# Access Compliance Report Public Rights-of-Way (Curb Ramps)

| Main Street: DORRANCE_DR                |                              | Cross Street: ST_IVES_WAY |                                         | Location:       | SW |
| ADA ID: RPRK211115114436                | Ramp Type: Type 4 - Parallel | Initial Pass/Fail: Pass   | Overall Compliance: No                  | Severity Score: | 30 |

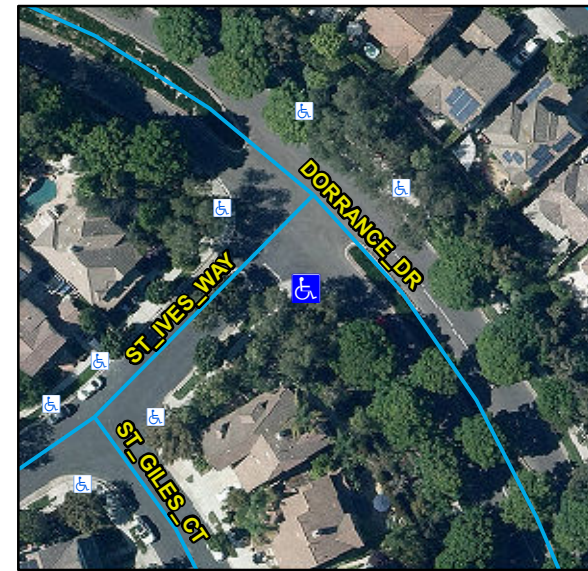
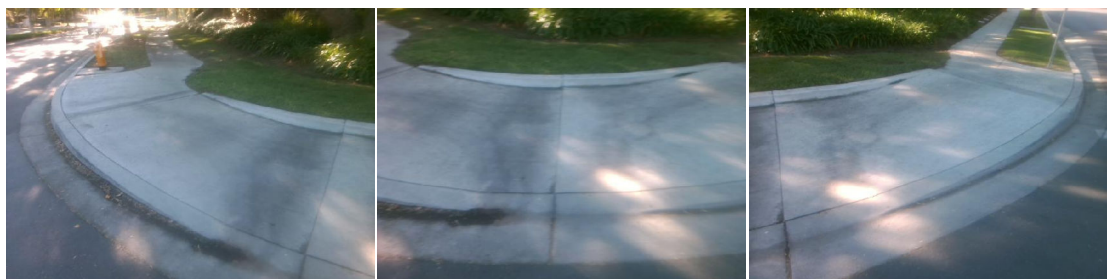
**R204.3, R304.2.1, R304.2.2-Perp, R304.3.2-Para, R304.5.3, R305, R302.7.2, STD 1115**

| Compliance | Description                   | Data       | Compliance | Description                   | Data |
|------------|-------------------------------|------------|------------|-------------------------------|------|
| N/A        | Landing Present               | No         | No         | DWS Provided                  | No   |
| No         | Landing Width (in)            | N/A        | N/A        | DWS Length (in)               | N/A  |
| No         | Landing Run Slope (%)         | N/A        | N/A        | DWS Full Width                | N/A  |
| No         | Landing Cross Slope (%)       | N/A        |            | DWS Offset Type               | N/A  |
| No         | Gutter Lip Height (in)        | 1.5        |            | Road Run Slope (%)            | 1.1  |

**Remove & Replace Curb Ramp With Two New Directional Ramps or Equivalent. Grind Gutter Lip.**
